**Beaver Valley Power Station
Unit Nos. 1 and 2**

**License Amendment Requests
302 and 173**

Extended Power Uprate

L-04-125

Figure 4.2-2

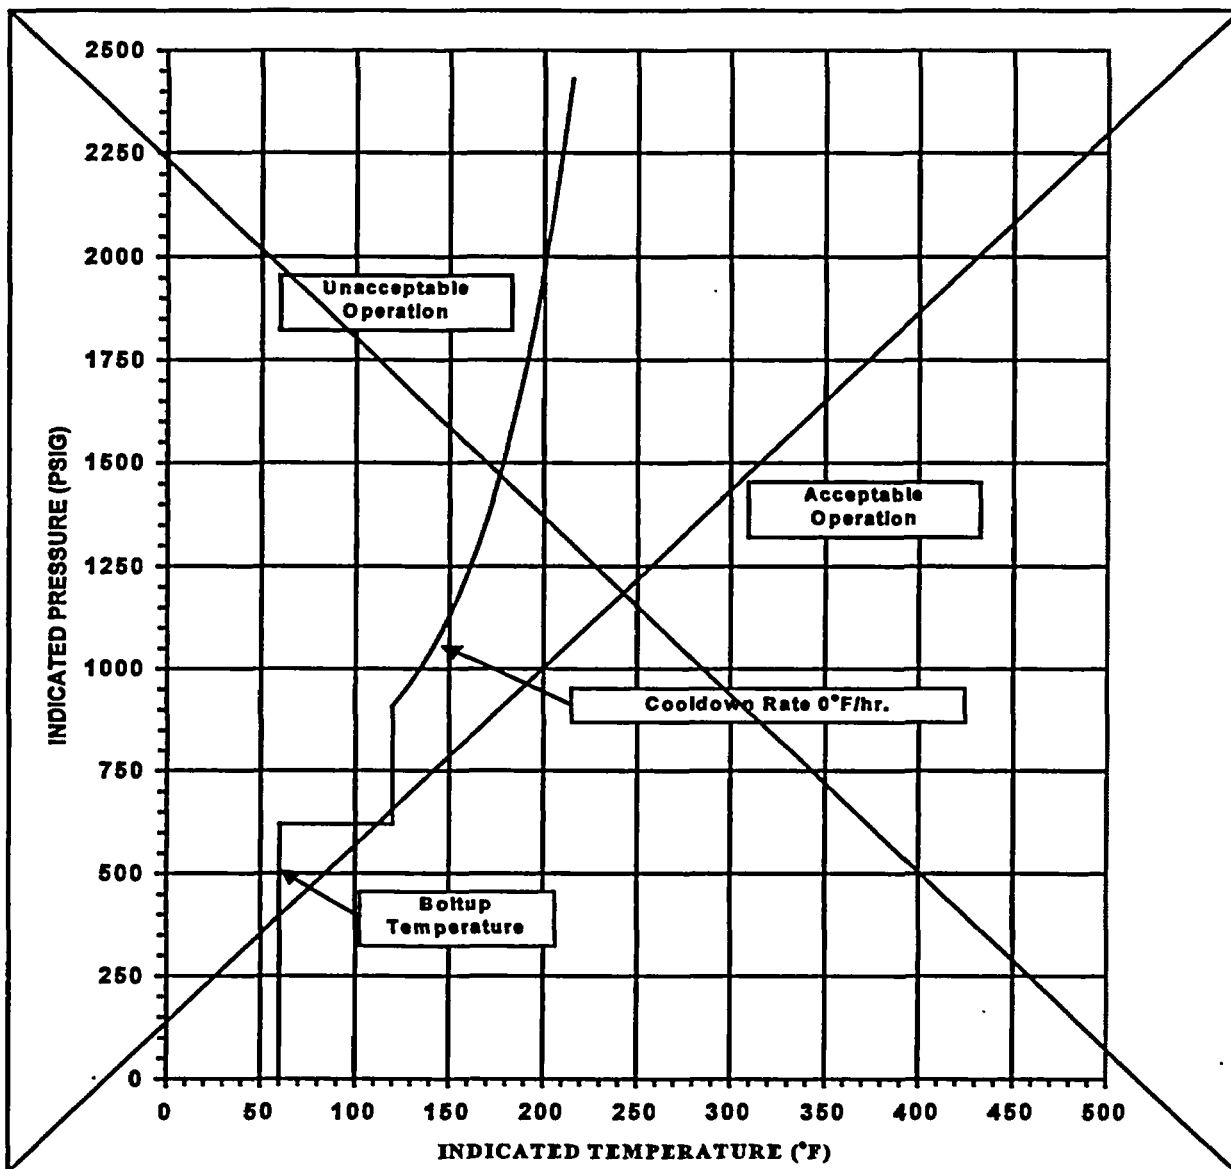
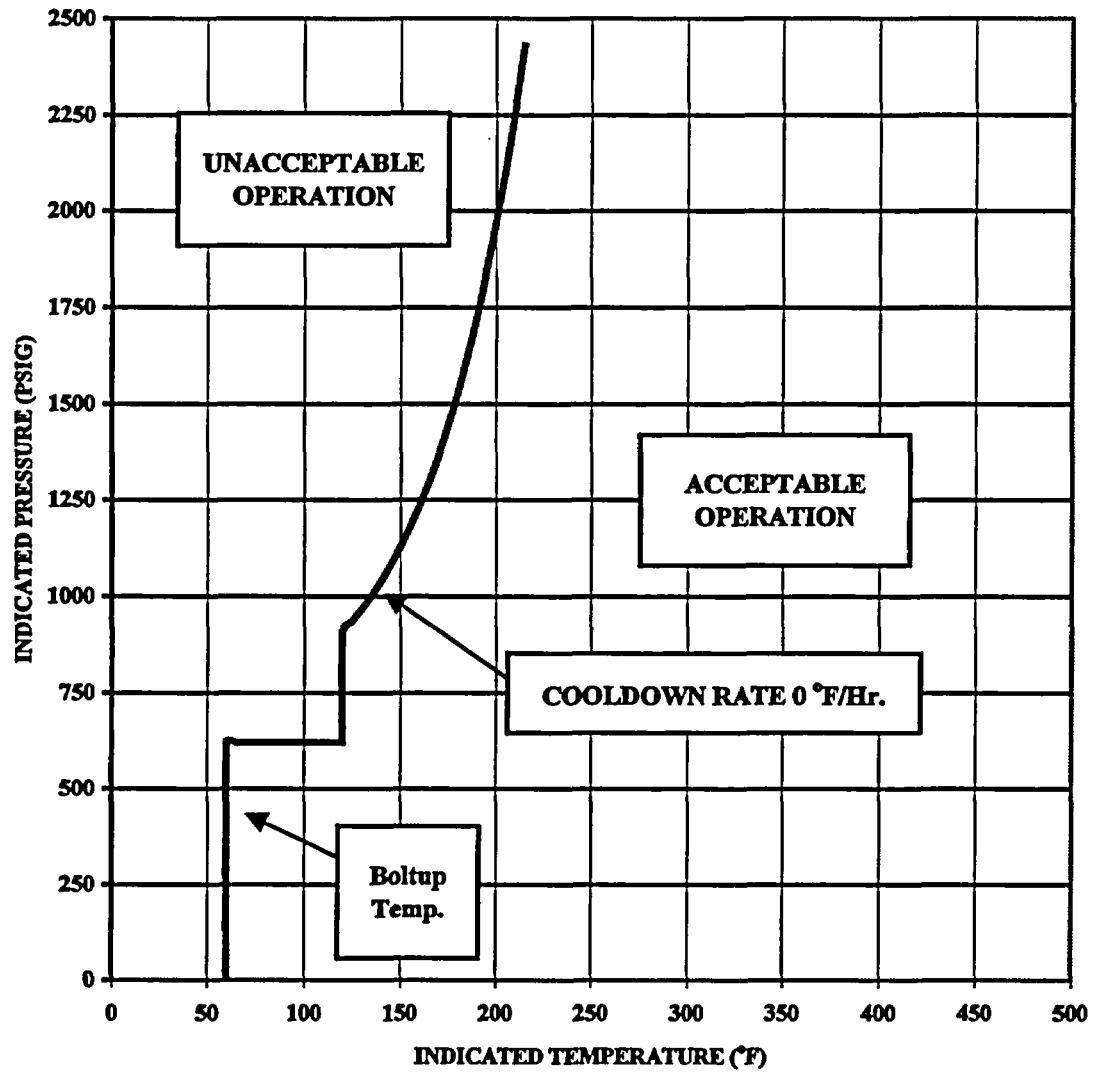
RT_{NDT} AFTER 1422 EFPY: 1/4T, 140°F
3/4T, 128129°F

Replace with
Insert C2-5.

Insert C2-5.

Figure 4.2-3

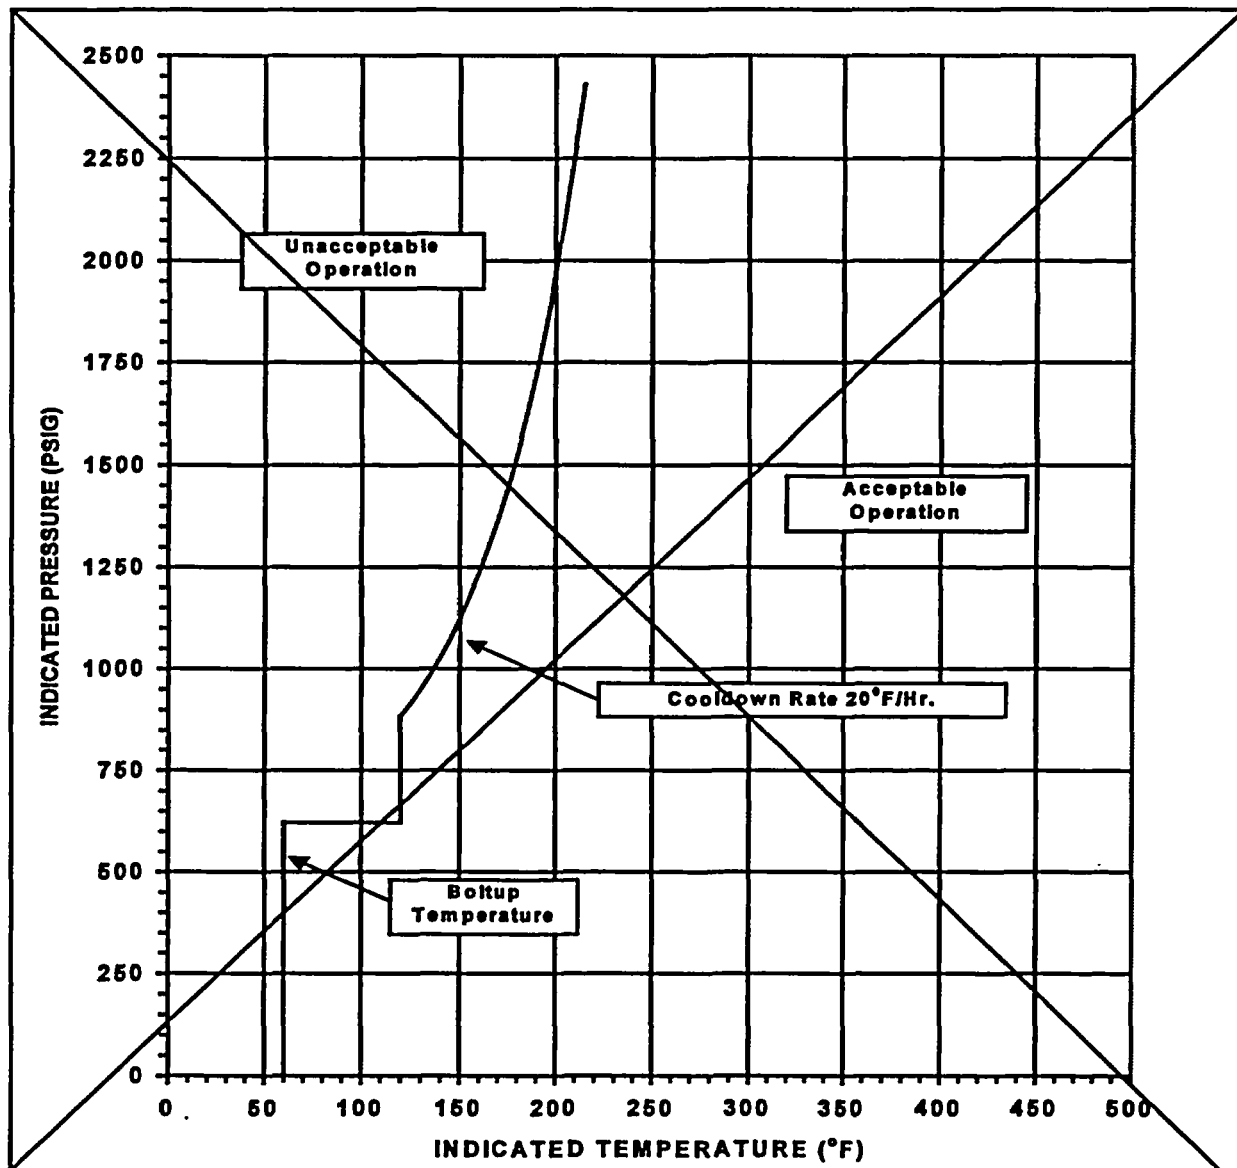
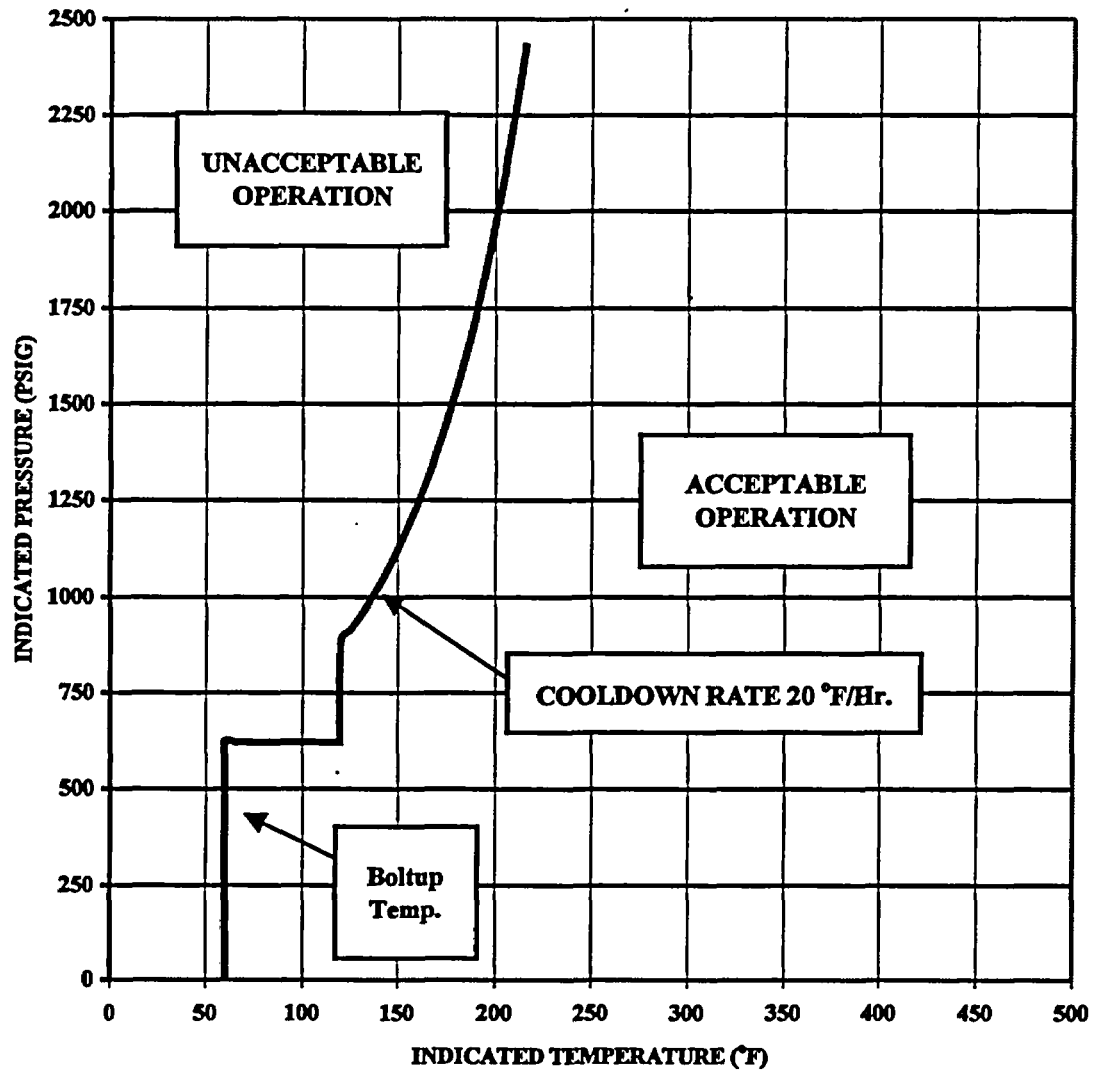
RT_{NDT} AFTER 1422 EFPY: 1/4T, 140°F
3/4T, 128, 129°F

Replace with
Insert C2-6.

Insert C2-6.

Figure 4.2-4

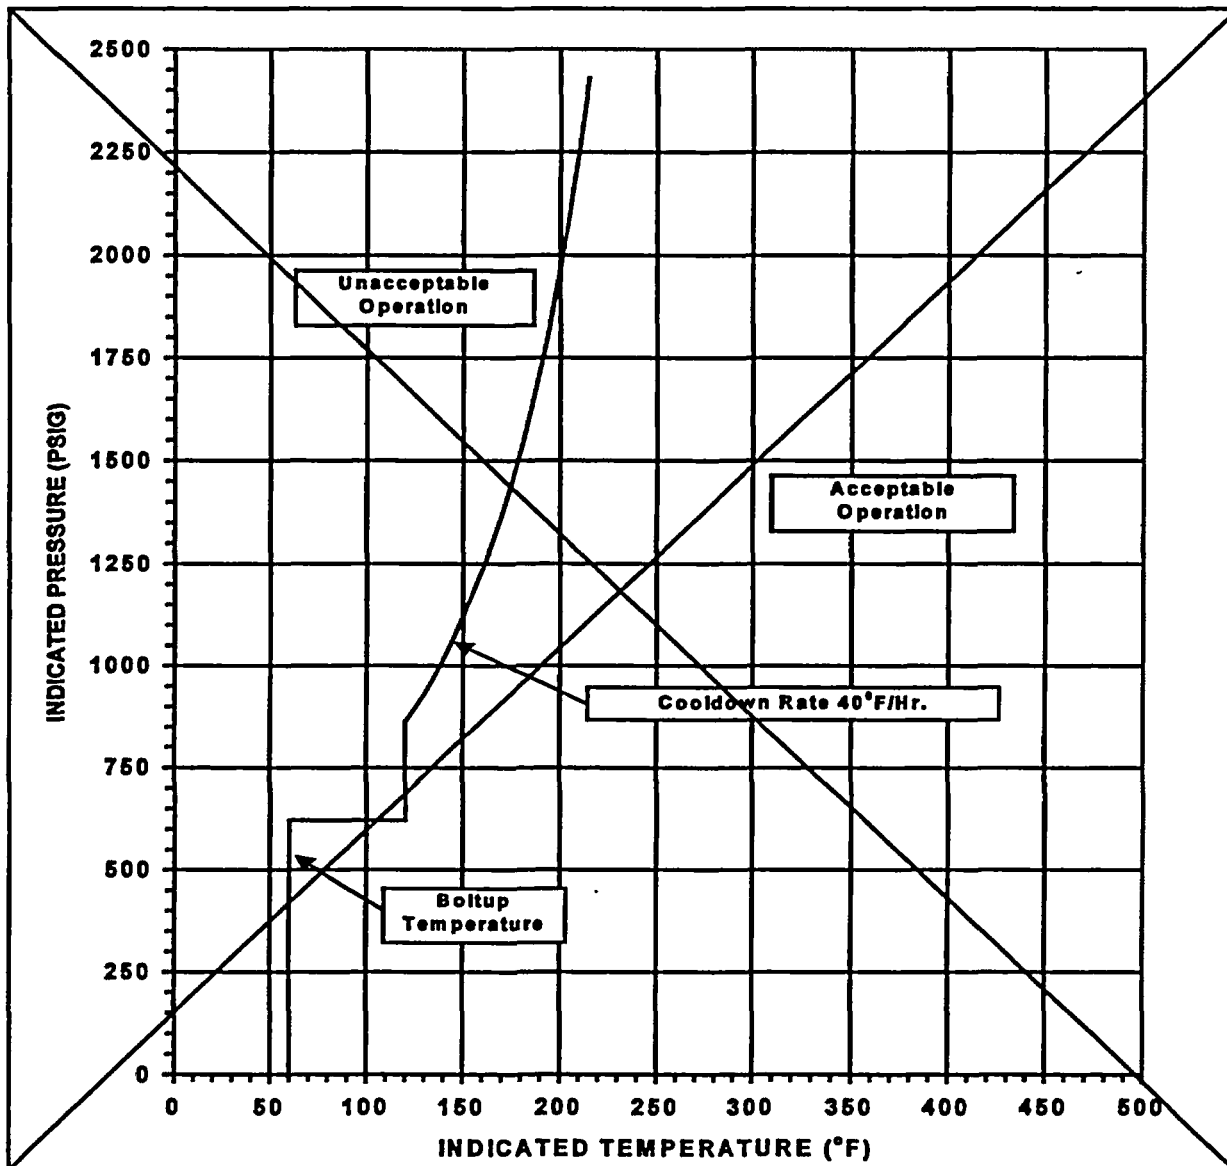
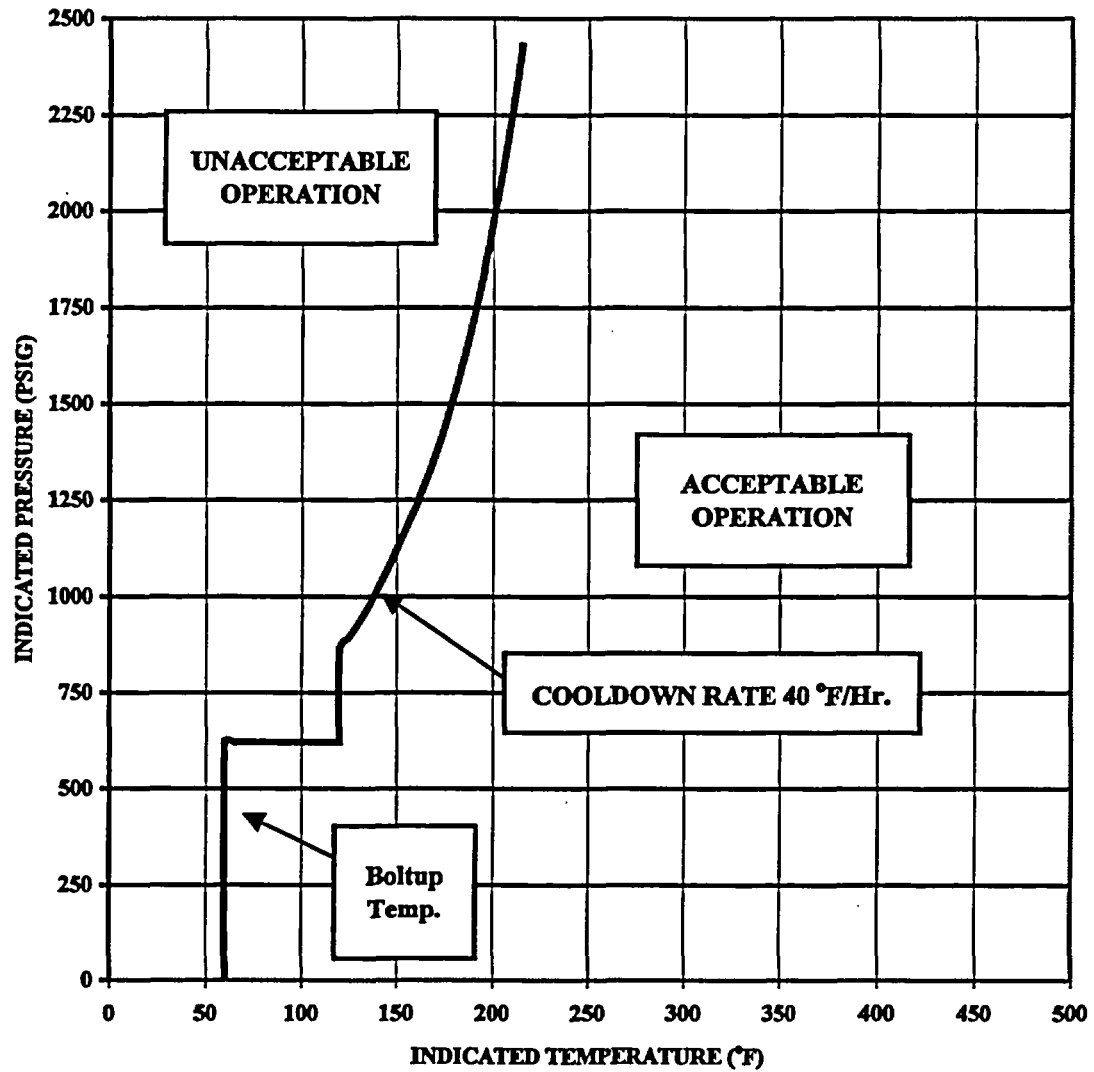
RT_{NDT} AFTER 1422 EFPY: 1/4T, 140°F
3/4T, 128129°F

Replace with
Insert C2-7.

Insert C2-7.

Figure 4.2-5
Reactor Coolant System Cooldown (up to 60°F/HR.)
Limitations Applicable for the First 1422 EFPY (TS 3.4.9.1)

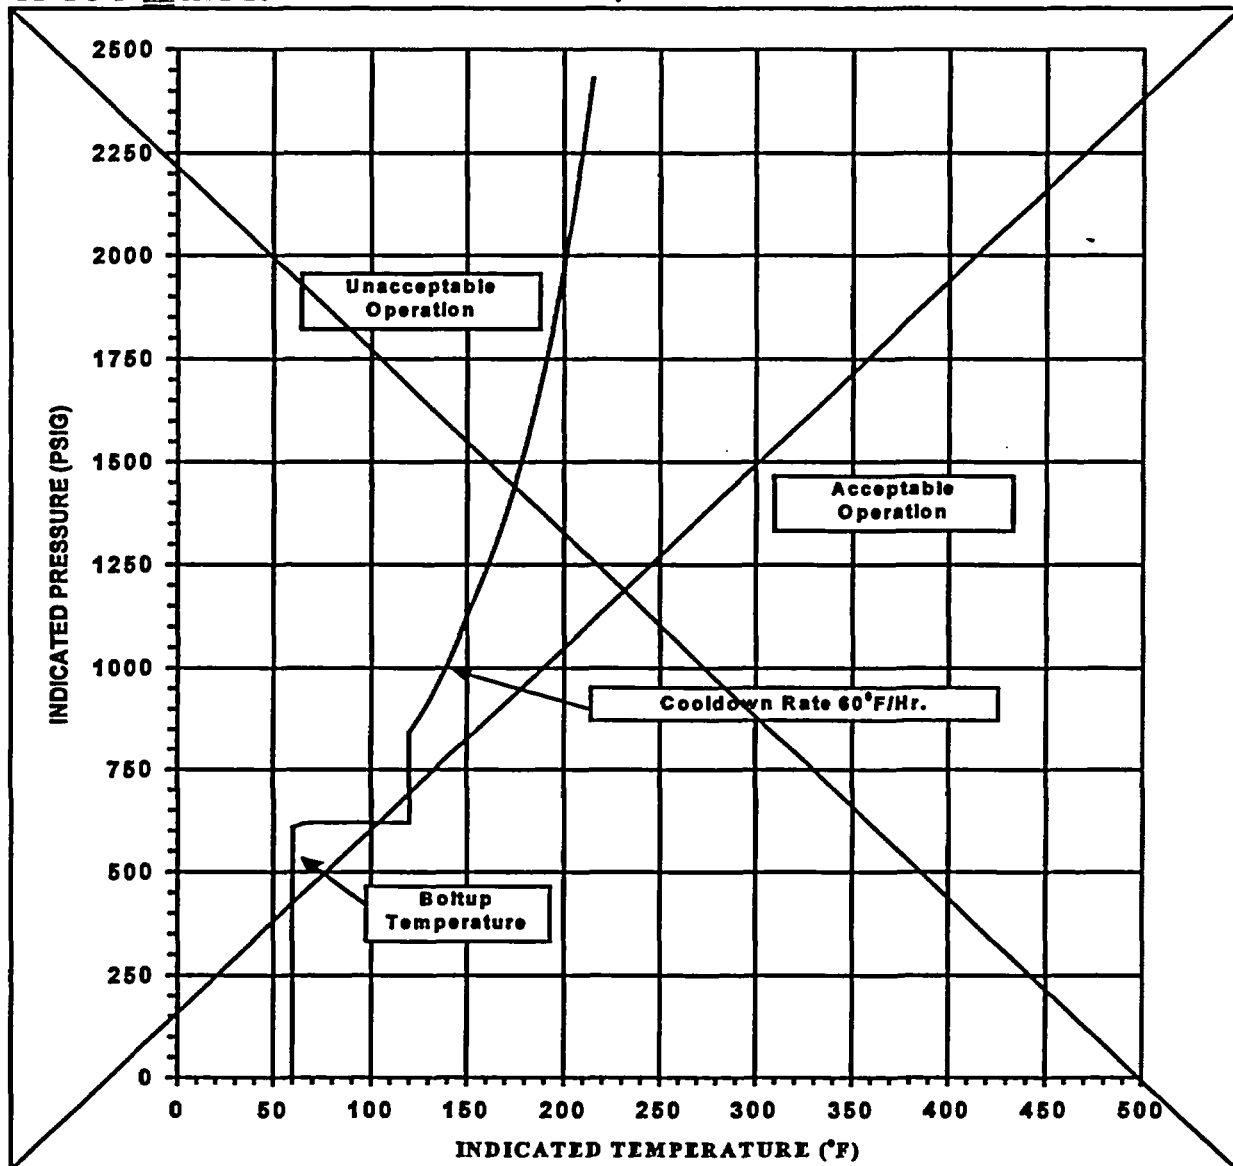
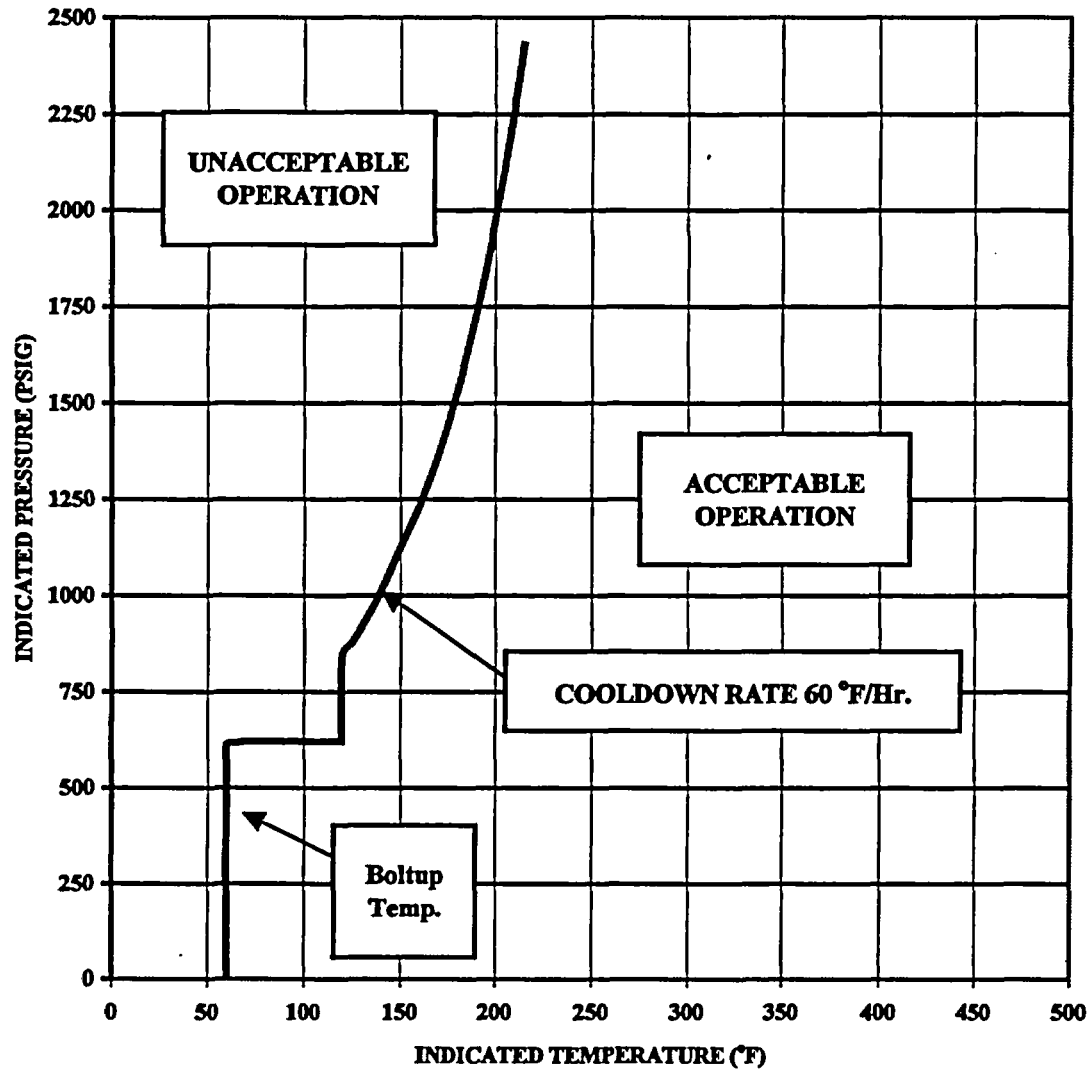
RT_{NDT} AFTER 1422 EFPY: 1/4T, 140°F
3/4T, 128129°F

Replace with
Insert C2-8.

Insert C2-8.
